Formula Renault 2.0 Northern European Cup DMSB Genehmigungs-Nummer: 505/14

Bulletin N° 06, 2014

Technical Bulletin N°2

REFERENCE	BT_2014_FR20_2_UK
DATE	April 24th, 2014
SUBJECT	Carbon floor extension repair
PART	Carbon floor, carbon floor extension

Carbon floor extension repair

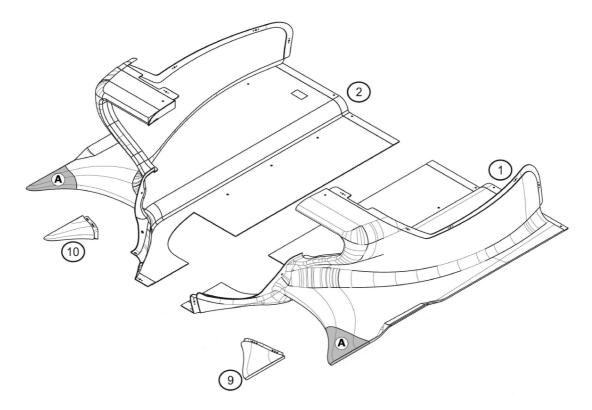
It is allowed to use carbon floors (n.1 & 2) with repaired front floor extension areas (areas (A)) with no change in weight and dimension.

Superficial repairs applied to the removable front floor extensions (n.9&10) are tolerated.

It is allowed to bond the removable extensions to the floor without modifying the extensions.
